MUNICIPAL OFFICE.

NOTICE UNDER SECTION 96 (1) CHAPTER IX OF THE BOMBAY
DISTRICT MUNICIPAL ACT III OF 1901 AS MODIFIED
UPTO THE 1st MARCH 1915.

— PLAN SHOWING PROPOSED BUILDING ON —
 — PLOT NO 62 & 63 SHEET M.R.4. —
 — MARKET QUARTER —
 — SCALE 8' = 1 INCH —

Case No. P/Q 404 of 1932.Applicant's Name Mr. Rangan.Architect's Name A. GijahPlot No. 62883 Sheet No. A. R. 4, Quarter

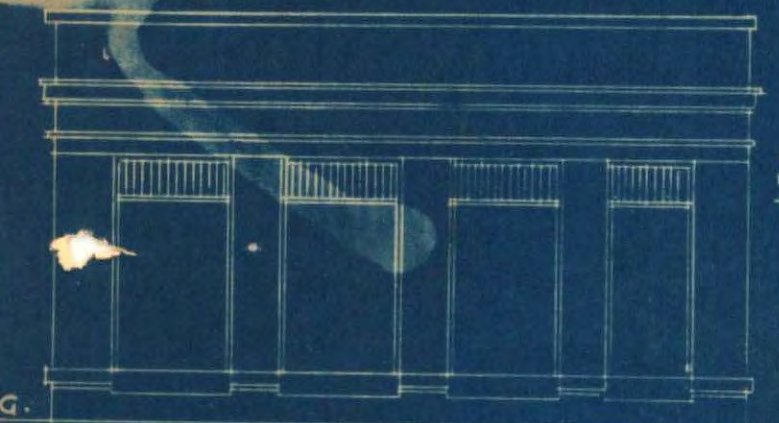
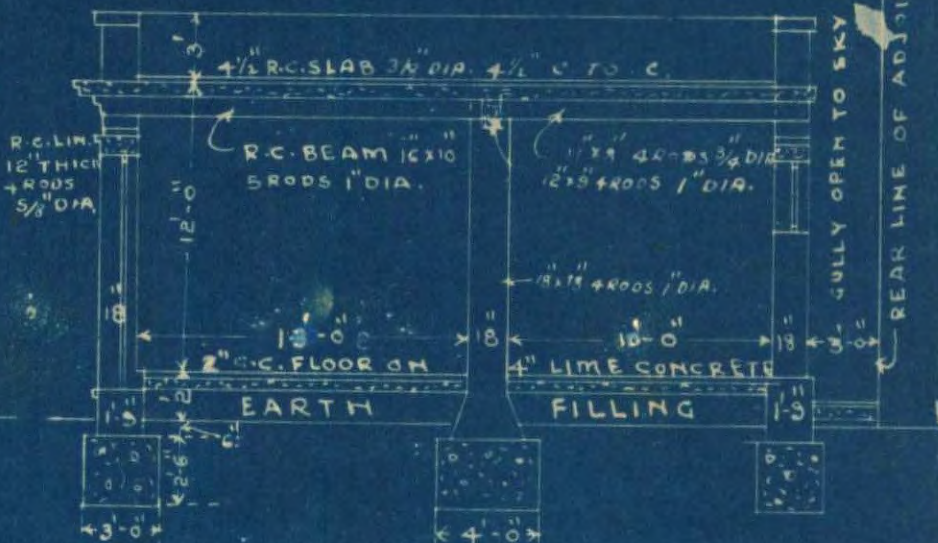
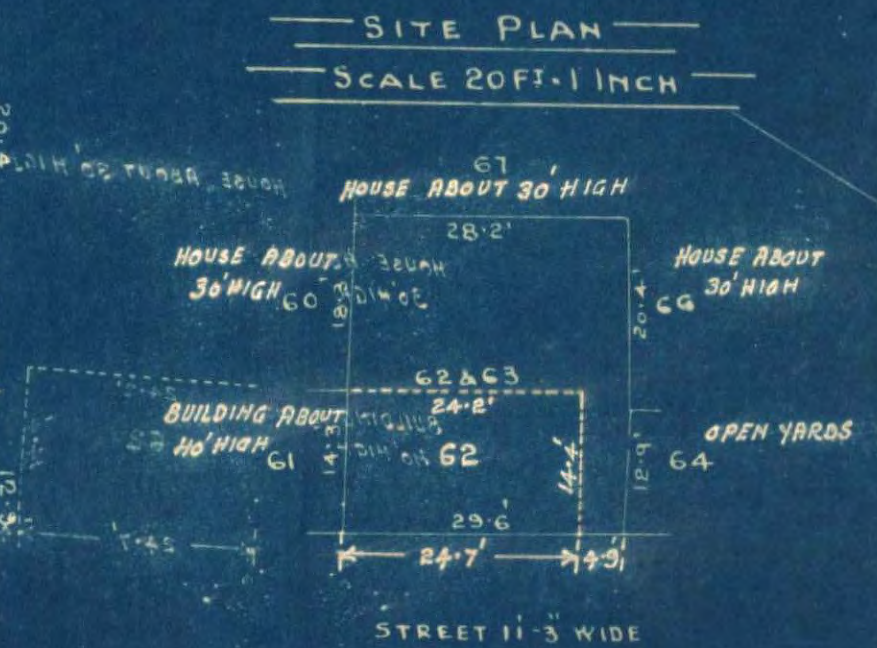
- 1) One building on two plots cannot be allowed unless they are first amalgamated
- 2) Size of animal pillars of the front wall must be written down.
- 3) Width of the gully should not be less than 5'.

- 1) On the site plan both the plots
must be shown distinctly.
- 2) The ^{height of} adjoining bldgs. must be written down
on the site plan

BB & dss of W.C & bath to be provided
as a precautionary measure & the windows
be of full size so that at any time the building
could be used for human habitation.

1. An application for amalgamation has been submitted to the City Deputy Collector and will shortly be approved.
2. Size of animal pillars is now shown on the plans.

3. The building is only one storey high and is not meant for residential purposes but as a godown and hence the owner is unwilling to leave anything more than the minimum. Your personal suggestion that the whole area should be built upon without gullies cannot be carried out as there are windows of adjoining buildings which open upon the plot whose owners will not give up their right of easement for air and light. If the Municipality assures the owner that he will have no trouble from adjoining owners with regard to windows, the owner will only too willingly follow your suggestion of closing up the whole area. We will note your suggestion for future guidance.

4. The two plots are now shown on the site plan.
5. Also the heights of the surrounding buildings.
6. As the building is only to be used as a godown there is no necessity for a bath and W. C..

PLAN SHOWING PROPOSED BUILDING ON
PLOT N^o 62 & 63 SHEET M.R.4.

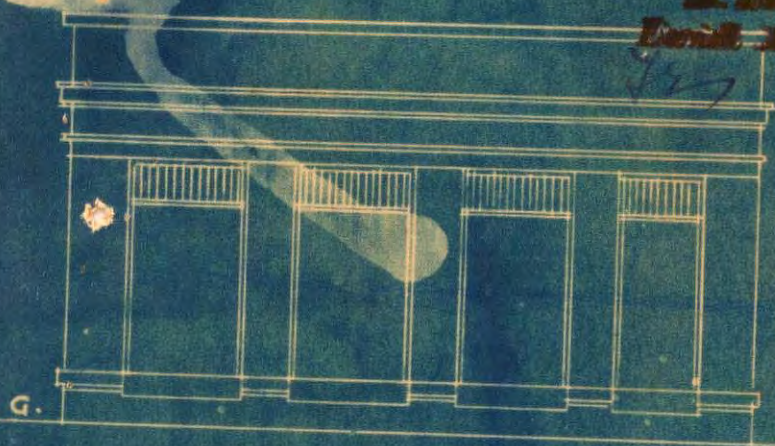
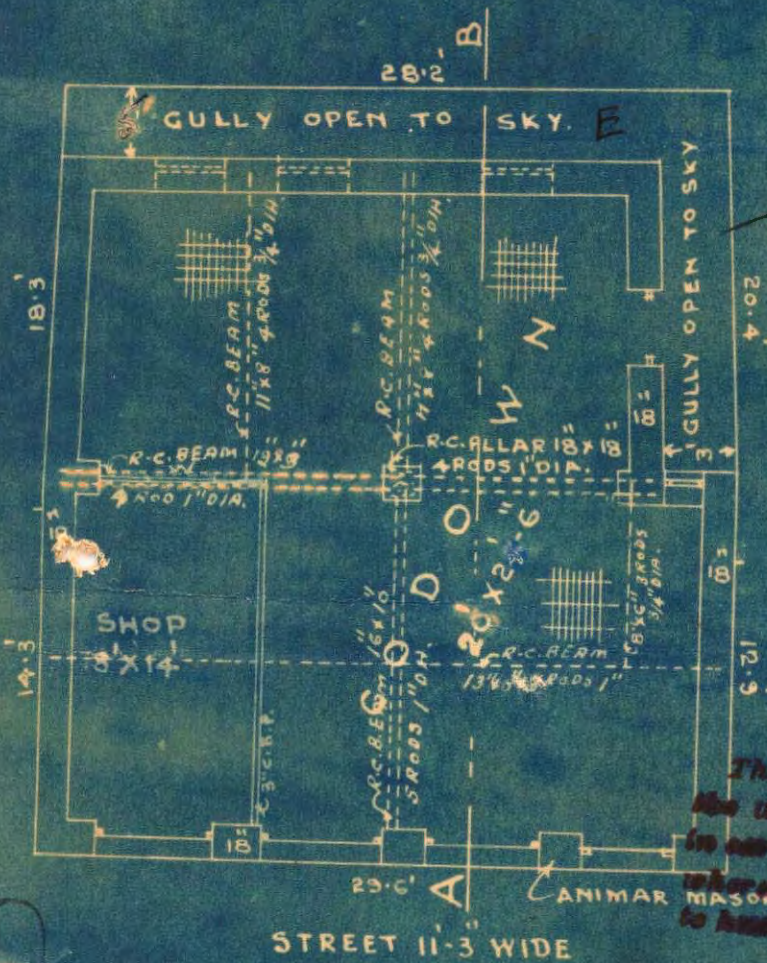
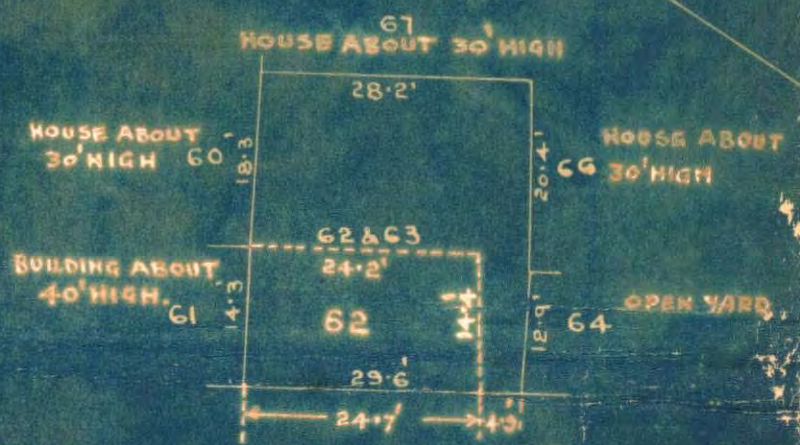
This was explained to the President in the presence
of the owner & it was decided that the owner should have
5' open width of 3' gully E. The gully F was allowed to remain 3'.
23/11

As agreed upon in presence of the
President, you are requested to leave 5'
open space instead of 3' gulley E. The ^{marked in the plan}
Gulley F to be allowed to remain 3'.

404/32 D. 23rd December 1932, and
under instructions from Mr. Mahmud
Ramzan, we beg to submit herewith
one copy of plan for building on
plots Nos 62 and 63 Sheet M.R. 4
Market Quarter duly corrected as
desired agreed upon.

Submitted, the architect
has complied with the
objection. The plan has
approved. 9/1/33
